FORD E4OD "UPDATE HANDBOOK"

*Updated
April, 2004*

VALVE BODY, SPACER PLATE, SPACER PLATE GASKETS, CHECKBALL LOCATIONS, AND CASE CHANGES, FOR THE 1996 MODEL YEAR

**89-95 MODEL
REVERSE CLUTCH STACK**

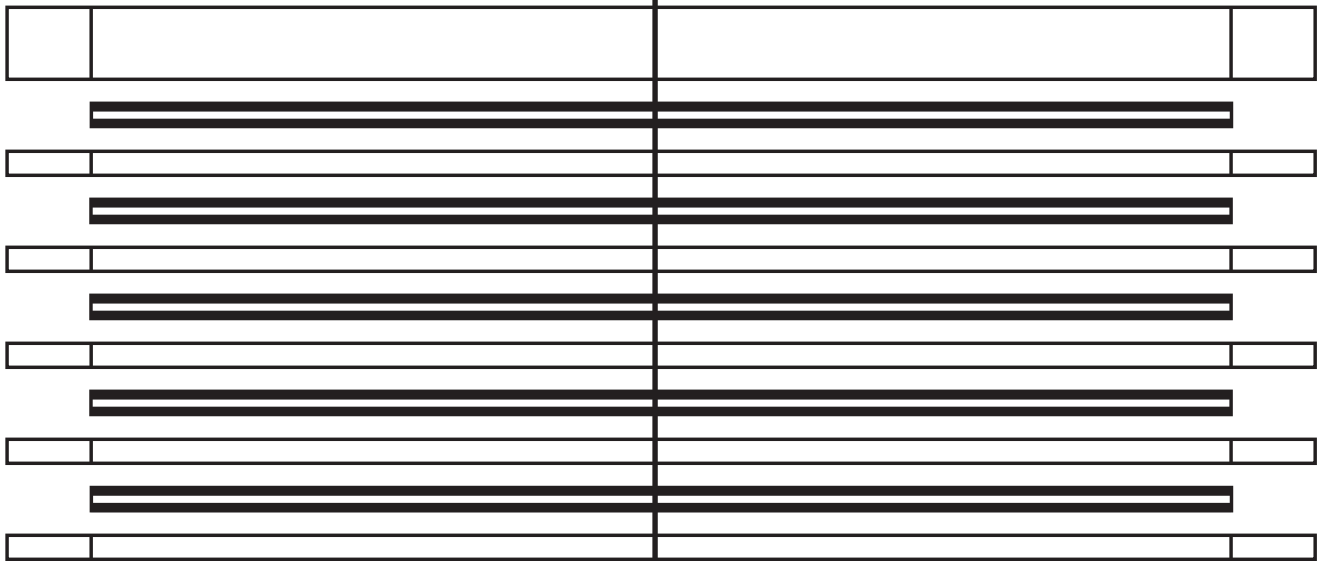
- (4) CUSHION (WAVE) PLATE - Added to the reverse clutch pack to cushion the reverse clutch apply, as shown in Figure 70. The new cushion plate when it is not compressed, is .140" in height and the nominal thickness is .080".

Figure 77
AUTOMATIC TRANSMISSION SERVICE GROUP

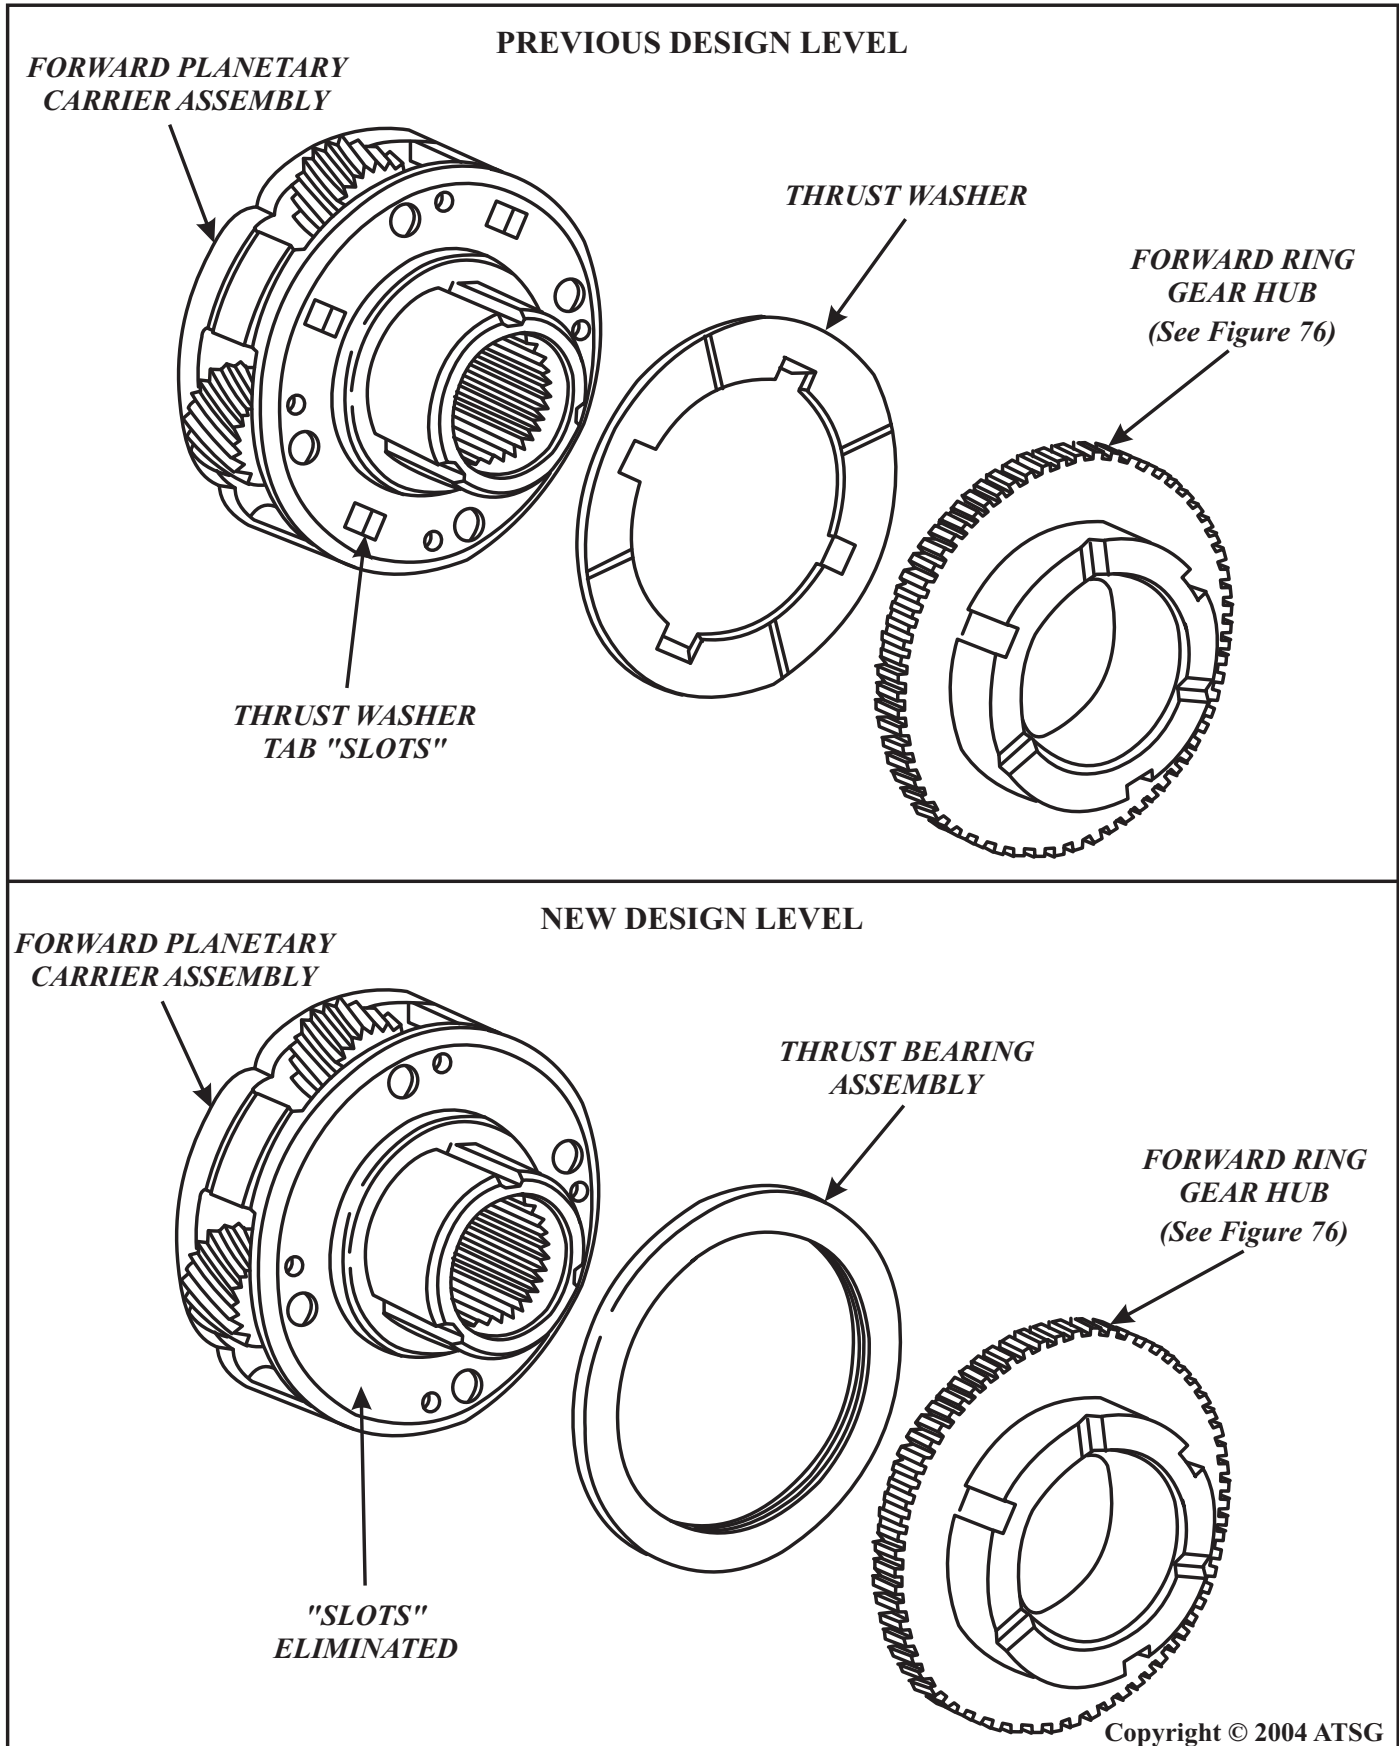
CHANGE: Beginning at the start of production for the 1997 model year, Ford Motor Company introduced a new design Forward Clutch Ring Gear Hub, to accommodate a new thrust bearing, that replaces the thrust washer on the forward planetary carrier, and a new design Forward Planetary Carrier that eliminates the thrust washer tab slots (See Figures 76 and 77).

- (2) New design Thrust Bearing must be used only with the new design Ring Gear Hub. It cannot be used on any previous models (See Figure 76).
- (3) There is also a new part number for the Forward Planetary Carrier, with no dimensional changes, and will retro-fit back on all previous models, but, ***some*** of the new part number carriers will not be cut to accept the four tang thrust washer. In that case you will have to install the new thrust bearing, which means you will also have to replace the ring gear hub with the new design level (See Figure 77).

Figure 78

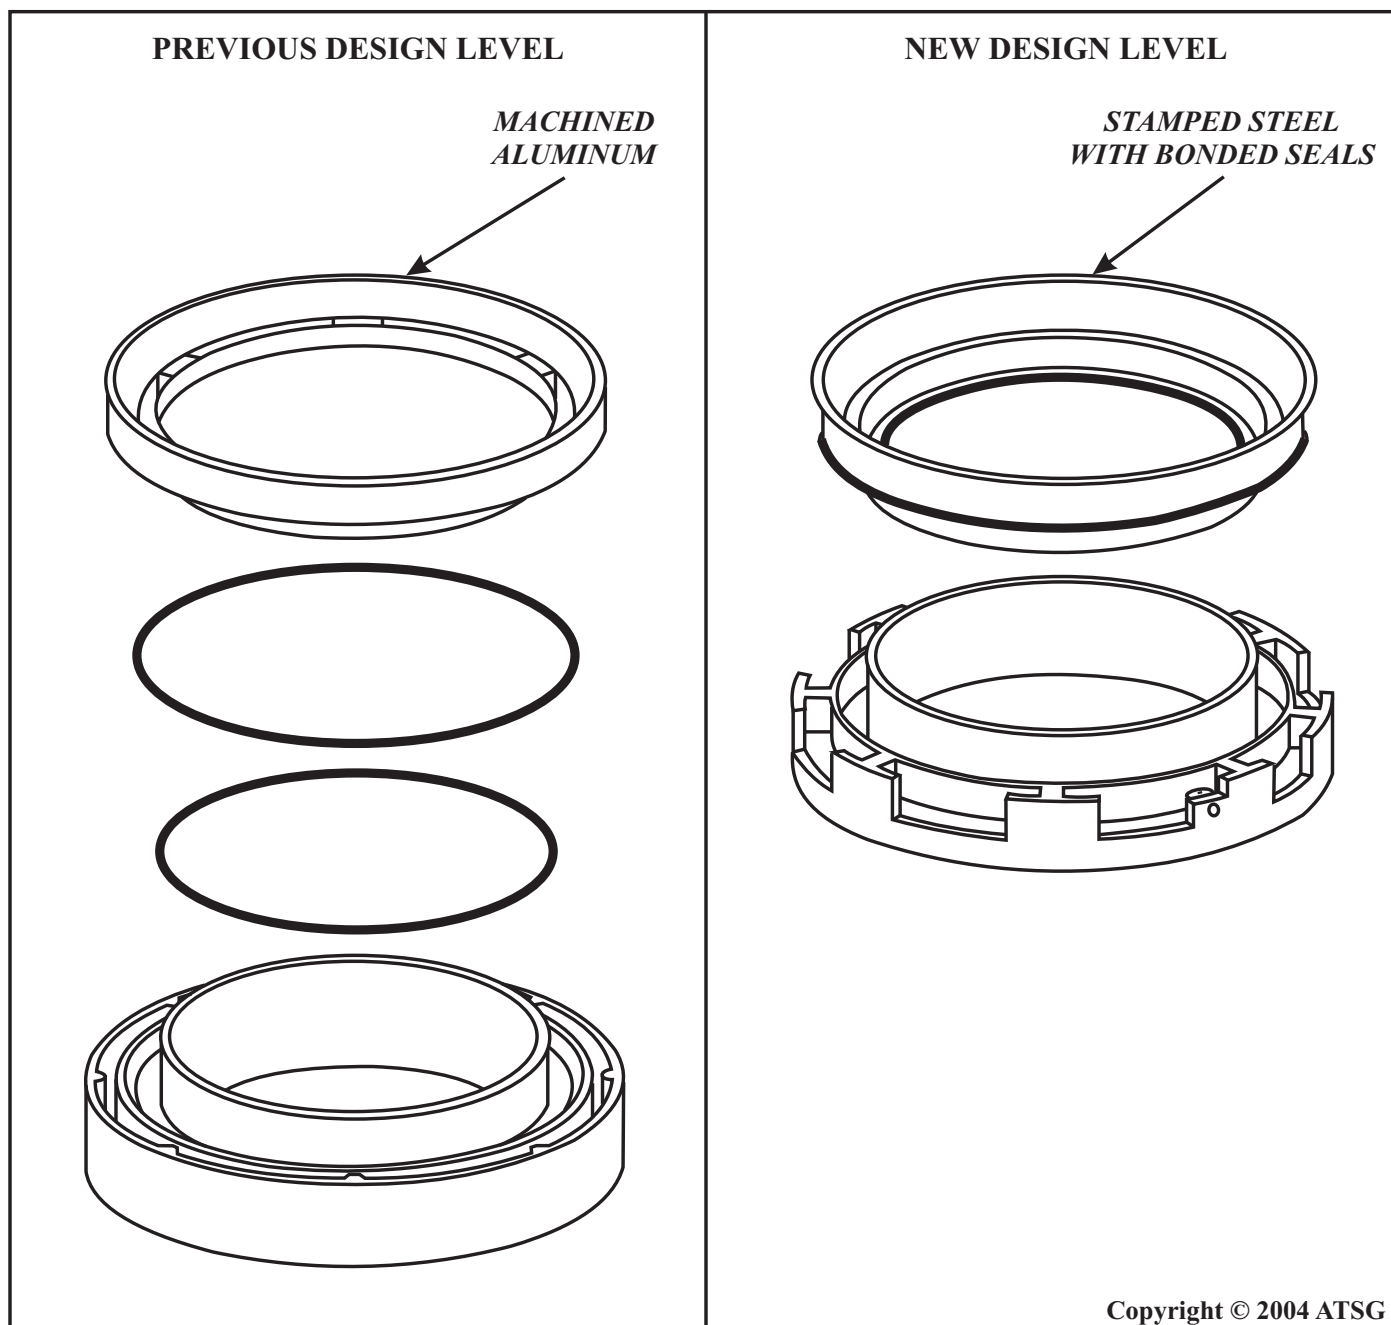
CHANGE: Some 1996-1997 vehicles equipped with the E4OD transmission were built with a new design level overdrive clutch piston, with the seals bonded to the piston (See Figure 78).

- (1) OVERDRIVE PISTON - Now stamped steel with moulded rubber inner and outer seals on the piston assembly, instead of the previous machined aluminum, as shown in Figure 78.
- (2) OVERDRIVE/INTERMEDIATE CLUTCH CYLINDER - Major casting changes to clutch cylinder, to accommodate the new design level bonded piston, as shown in Figure 78.

Figure 79

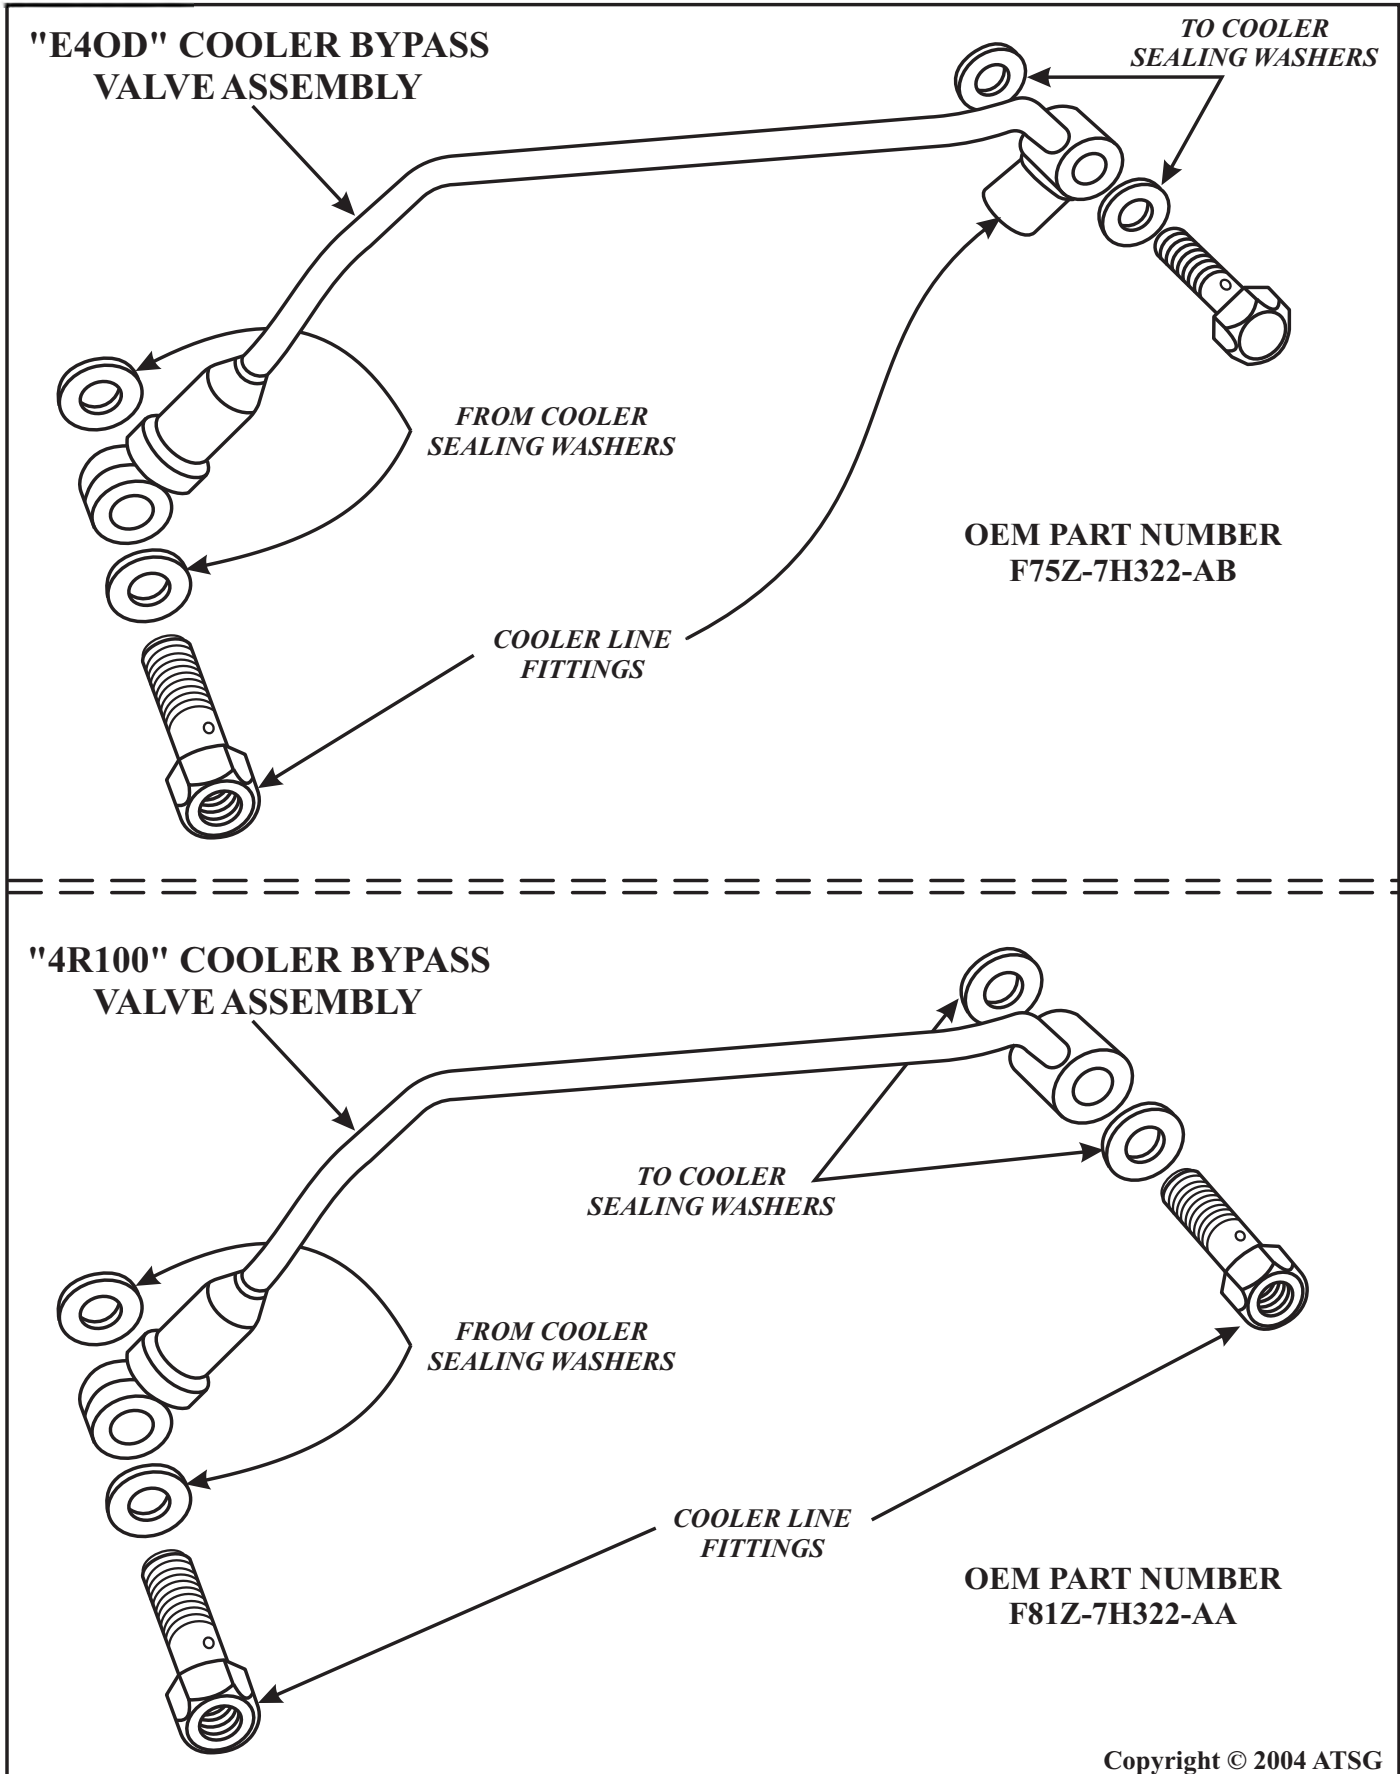
CHANGE: Some 1997 Econoline, Expedition, F-150 Trucks and F-250 Trucks have been equipped with a Cooler Bypass Valve Assembly that requires sealing washers on both the "To Cooler" end and "From Cooler" end of the bypass valve assembly, as shown in Figure 79.

- (1) COOLER BYPASS VALVE ASSEMBLY - Added between the cooler line fittings in the case, to increase lube flow during cold weather operation (See Figure 79).
- (2) CASE FITTINGS - Requires special case fittings to retain the "Banjo" ends of the cooler bypass valve assembly into the transmission case (See Figure 79).
- (3) SEALING WASHERS - Requires sealing washers on both of the "Banjo" ends of the cooler bypass valve to seal properly (See Figure 79).

The new design Cooler Bypass Valve Assembly will retro-fit back to all previous models, and we would recommend the 4R100 style bypass valve assembly, as shown in Figure 79, because you do not have to bend the existing cooler line to get it hooked up.

Figure 80

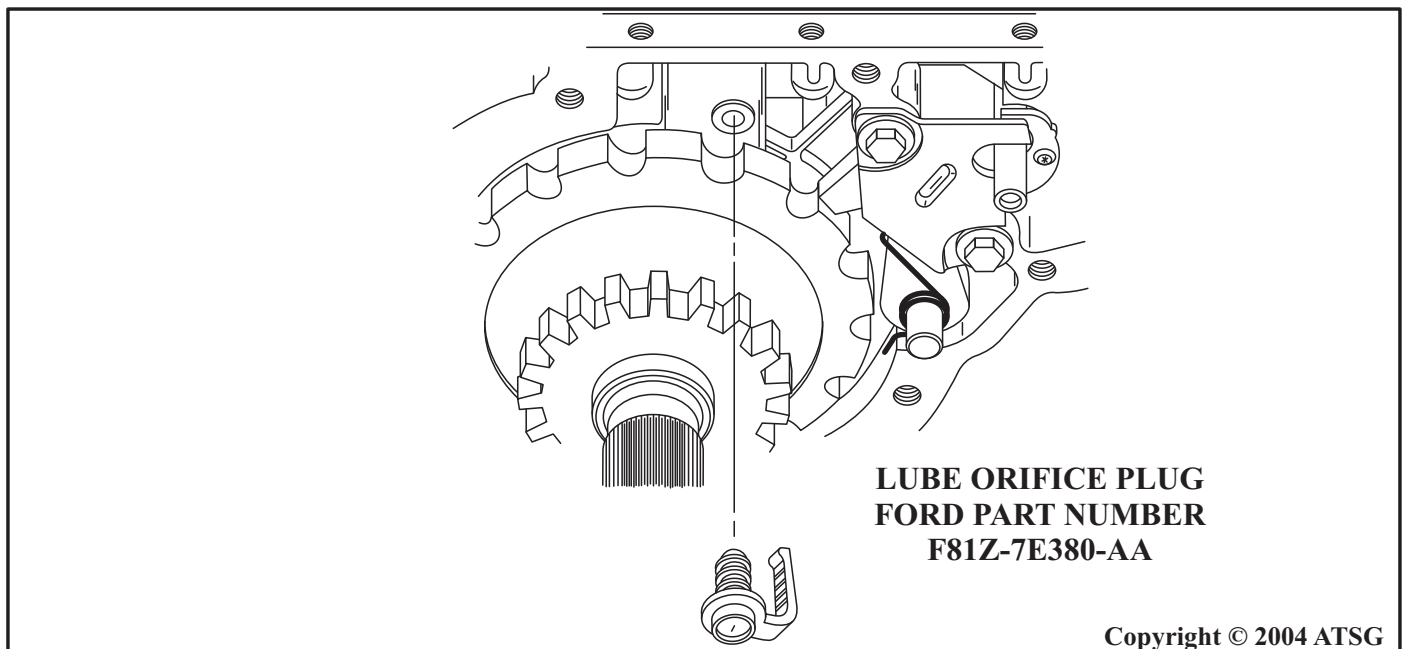
- (1) TRANSMISSION CASE - Added passage at the rear of transmission case to accept the added plastic lube orifice plug, as shown in Figure 80.
- (2) EXTENSION HOUSING - Added cast-in shoulder/boss that retains the added lube orifice plug in the transmission case, as shown in Figure 81.

Figure 83

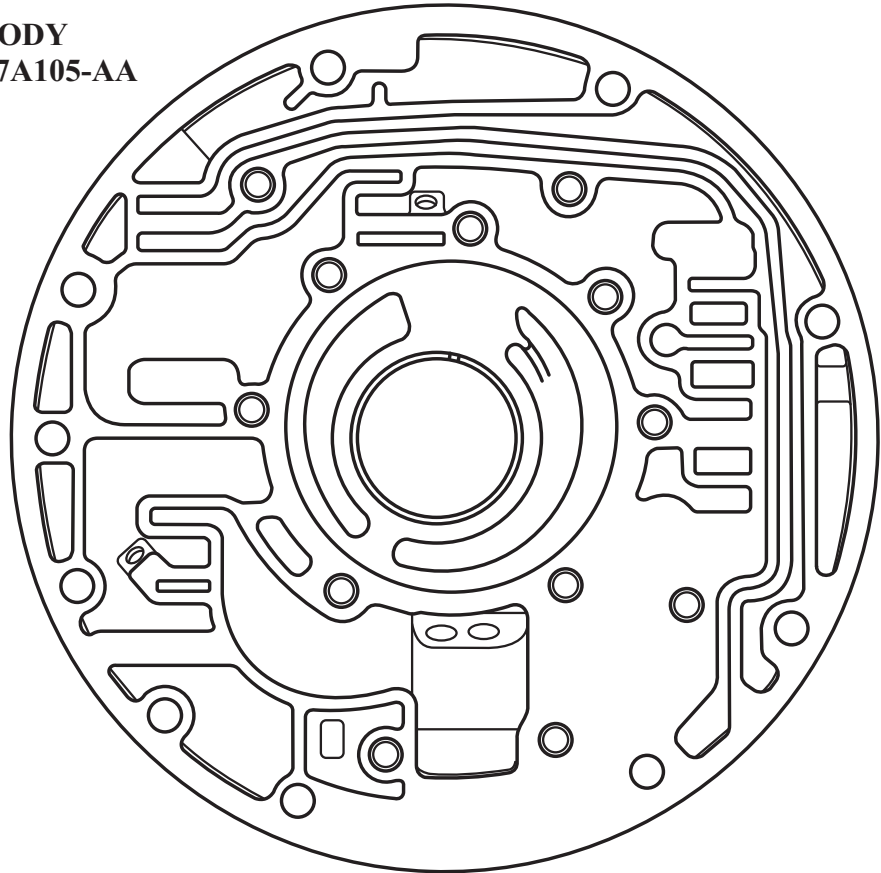
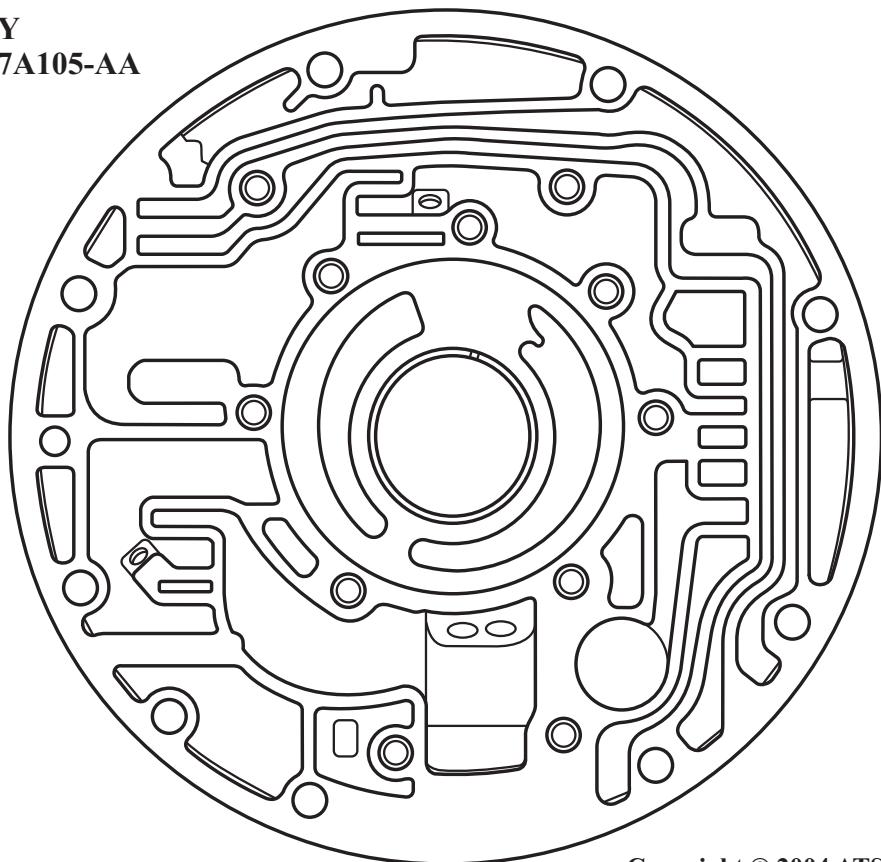
- (1) OIL PUMP BODY - Now has different worm tracks to accommodate the new pump cover assembly and is identified by the rough forging number RF-F81P-7A105-AA, and is cast into the pump body in the location shown in Figure 82. The worm track side of the new pump body and the previous pump body are shown in Figure 83.
